<b>Docket Number:</b>	19-SPPE-02
<b>Project Title:</b>	Walsh Data Center
<b>TN #:</b>	234265
<b>Document Title:</b>	2HT comments on PD
<b>Description:</b>	2HT comments on PD
<b>Filer:</b>	Robert Sarvey
<b>Organization:</b>	Robert Sarvey
<b>Submitter Role:</b>	Intervenor
<b>Submission Date:</b>	8/7/2020 2:25:34 PM
<b>Docketed Date:</b>	8/7/2020

Walsh Data Center

Helping Hand Tools (2HT) Comments on the Proposed Decision

### Lafayette Data Center 44 - 3 MW Diesel Generators

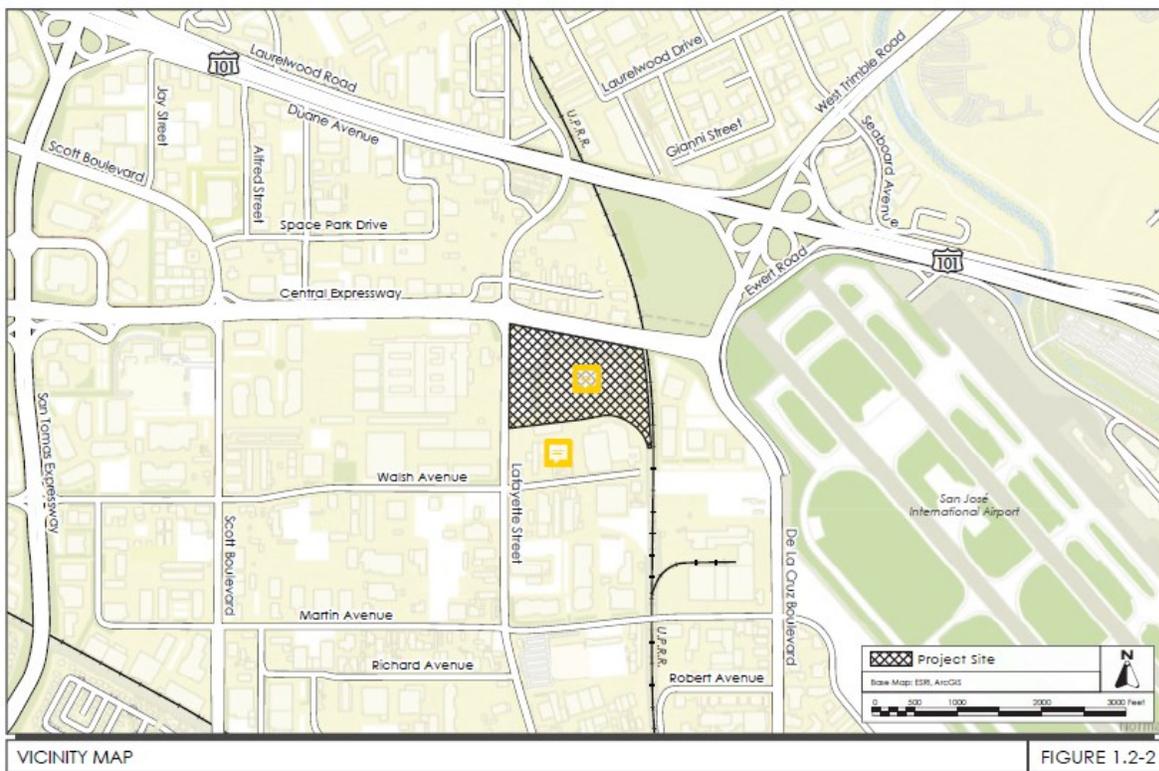
Digital Realty is the proponent of the 80 MW Walsh Data center.<sup>1</sup> Digital Realty is also the owner of the 99 MW Lafayette Data Center which is located adjacent to the Walsh Data Center on the same block as depicted in the two maps extracted from the projects applications as shown below.

**FIGURE 1**  
**Walsh Backup Generating Facility Vicinity Map**

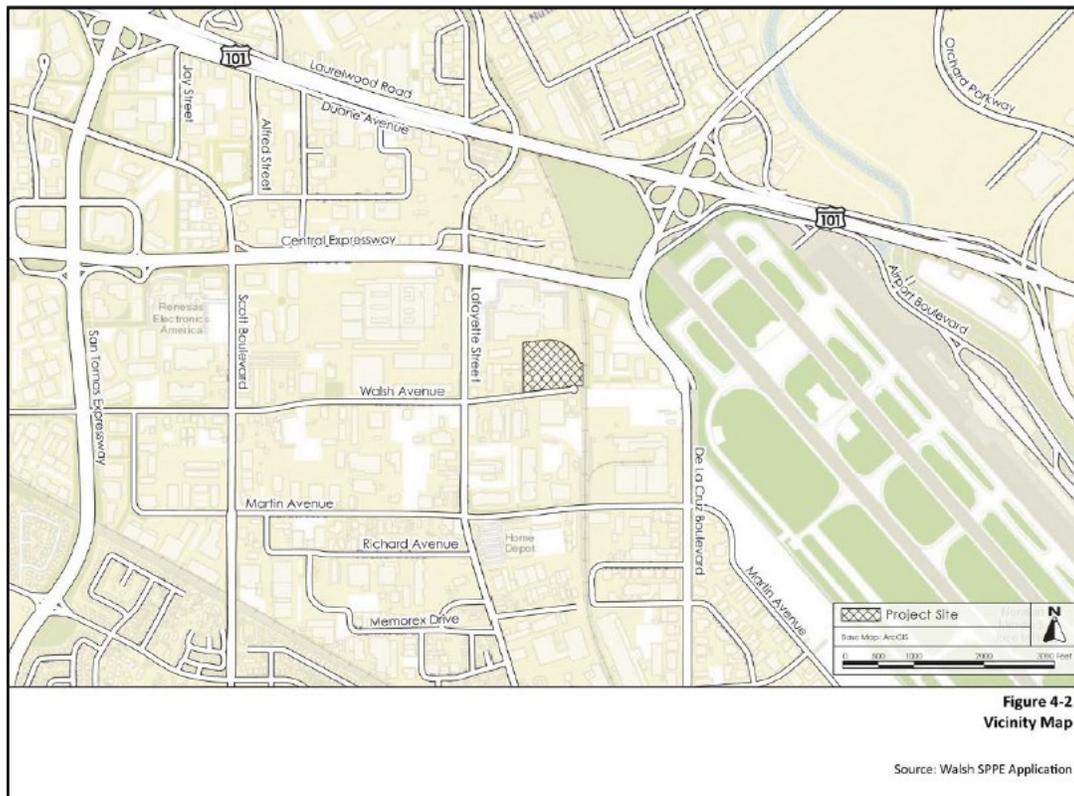
Since both projects are owned or controlled by Digital Realty and located adjacent to each other with no intervening streets or parcels, and they are now part of a reasonably foreseeable plan of development, they constitute the same project. The combined generating capacity of the two projects is 179 MW which necessitates the applicant to file an Application for Certification. CEC Staff and the applicant were aware of both projects before the Walsh evidentiary hearing<sup>4</sup> but failed to provide the information to the Committee despite having the same CEC staff attorney and the same
